# A Review of the RFQ Based Pre-injector for the Fermilab Linac

September 1, 2011, FNAL

Figure 2: Operation of the pulse Einzel Lens

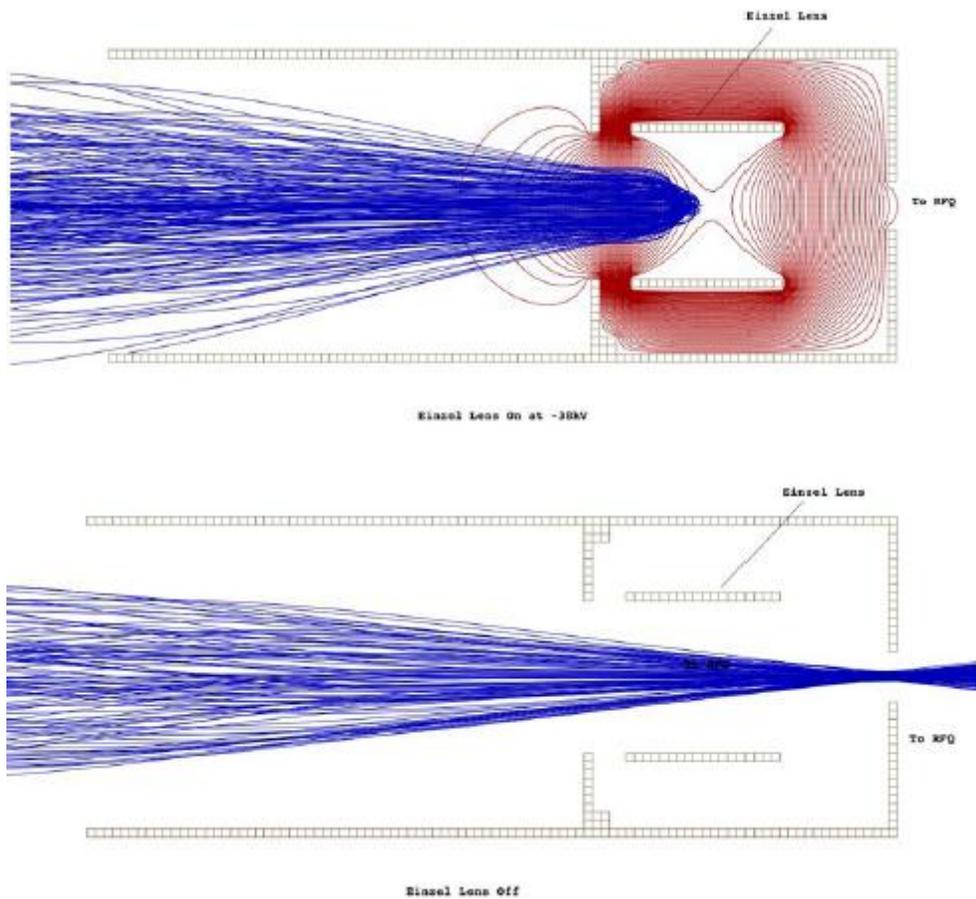
The only new feature is the use of the Einzel Lens to create a longitudinal field serving as a beam chopper. As far as we know, this has never been done before. In addition to the possibility of problems with the high speed pulser, the ion beam which is reflected may affect the Xe space charge neutralization, possibly resulting in subtle changes to the beam.

Because a small portion (3 microsec) of the 30 to 60 microsec Linac beam to the Booster is adversely affected by the Linac RF Stations and must be dumped, the committee was not convinced of the stringent rise and fall times (tens of nanoseconds) placed on the Einzel Lens pulser.

4. There needs to be a specific backup plan if the current Einzel Lens pulsing scheme doesn't work due to high speed pulsing or neutralization problems. Neutralization with Xe should be studied early to check for subtle issues during the turn on
